CONSTRUCTION CONTRACT CHANGE ORDER NUMBER:

001

BRUSHY CREEK REGIONAL TRAIL PH 5

CP 01R - DRAINAGE CHANGES

FRENCH DRAIN DETAIL PER EMAIL DATED 11/6/19

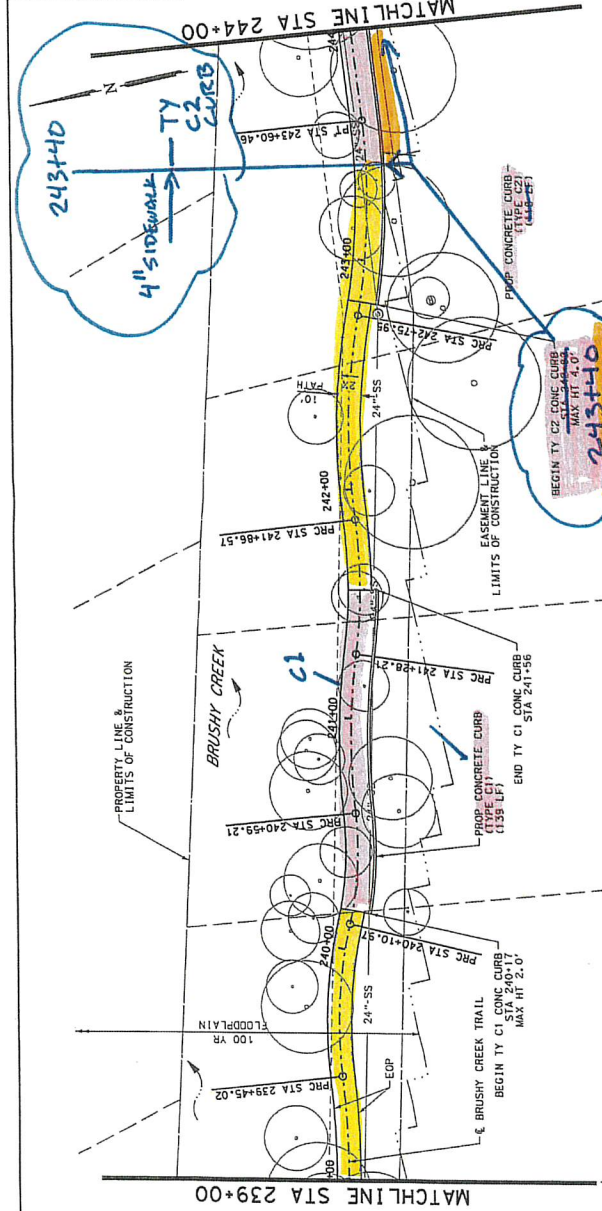
Based on field conditions, LA and Civil modified lengths and positions of various CONC CURBS. French drain added at STA 243+40 to aid drainage. See attached. A copy of this CO should be sent to the Field Coordination Section of the Design Division.

FRENCH DRAIN DETAIL 243+40 - 245+00	LF	\$50.00	160.00	\$8,000.00
		4" PVC PIPE OUTFALL 10 LF	EA	\$500.00	3.00	\$1,500.00
		4" FLAP VALVE ALLOWANCE	EA	\$500.00	3.00	\$1,500.00
		UNUSED REBAR PREVIOUSLY APPROVED AND DELIVERED	LS	\$1,000.00	(1.00)	(\$1,000.00)
						\$10,000.00

BRUSHY CREEK TRAIL
PLAN AND PROFILE
(STA 249+00 TO STA 254+00)

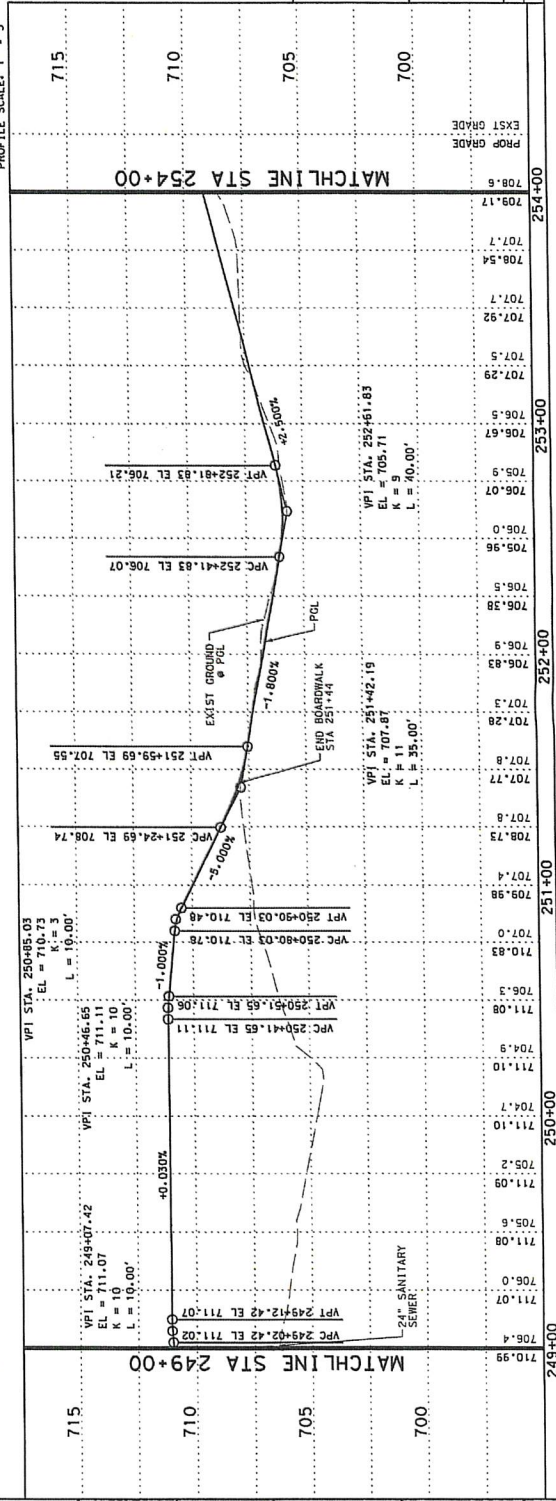
NO CHANGE TO F3 CURB
THIS SHEET

TYPE "C2" CURB - MODIFIED
w/ FRENCH DRAIN

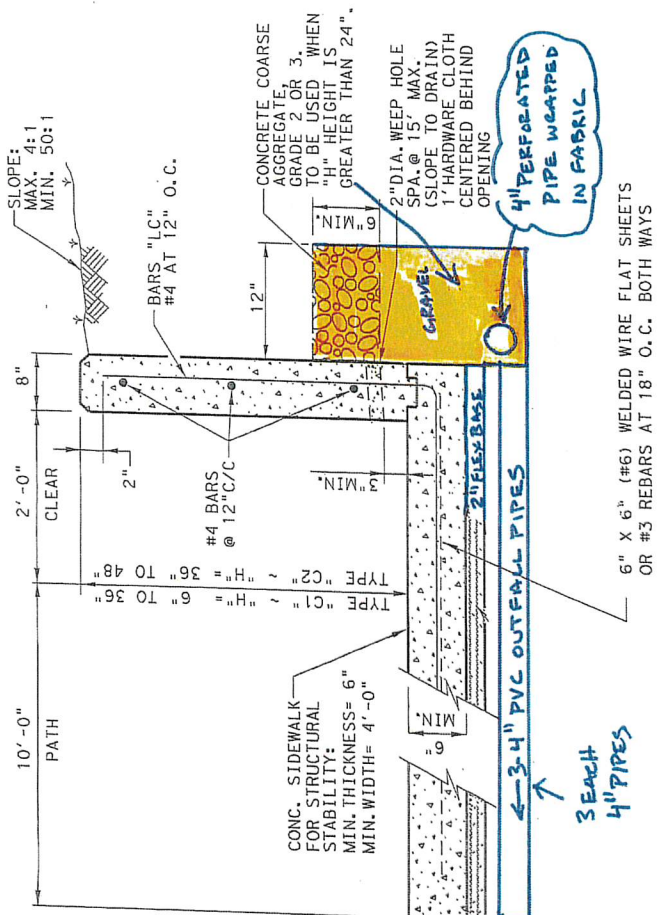
3 Each
4" PIPES
